# RENESAS TECHNICAL UPDATE

Product Category	MPU/MCU		Document No.	TN-V85-A035A/E	Rev.	1.00
Title	Misdescription in the electrical characteristics of the bus timing		Information Category	Technical Notification		
Applicable Product	V850ES/FJ3, V850ES/FJ3-N series V850ES/FK3, V850ES/FK3-N series	Lot No.	Reference Document	Data Sheet & User Manual : Hardware of applicable products		
		All lots

Figure 9-9 Timing: write data with address setup/hold wait (bus size: 16-bit)

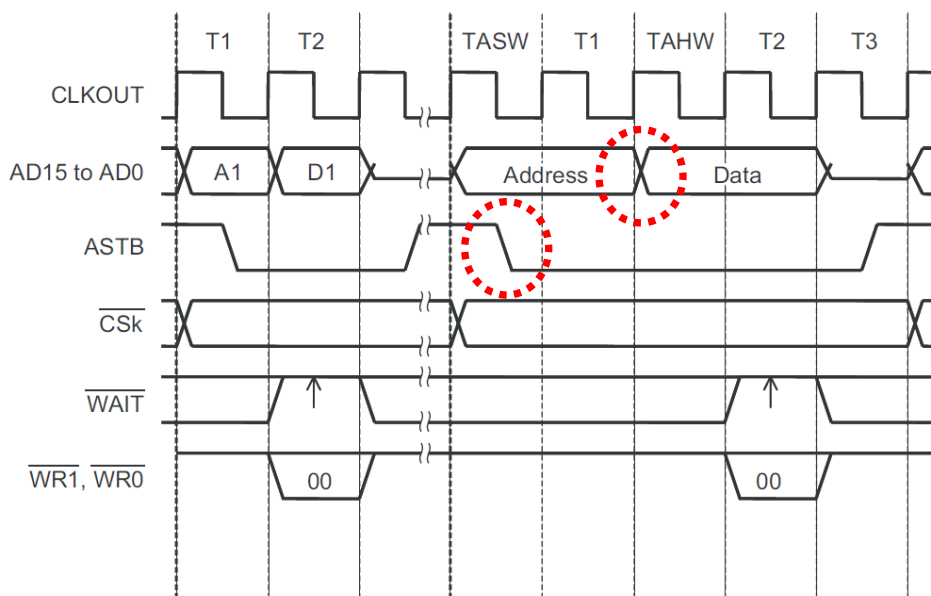
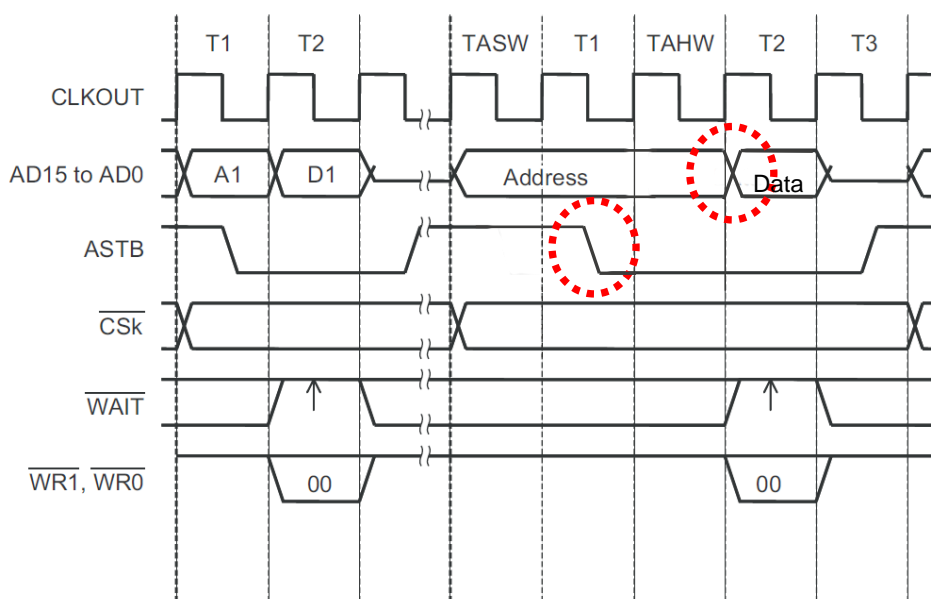
The figure of “Timing: write data with address setup/hold wait (bus size: 16-bit)” is changed as below.
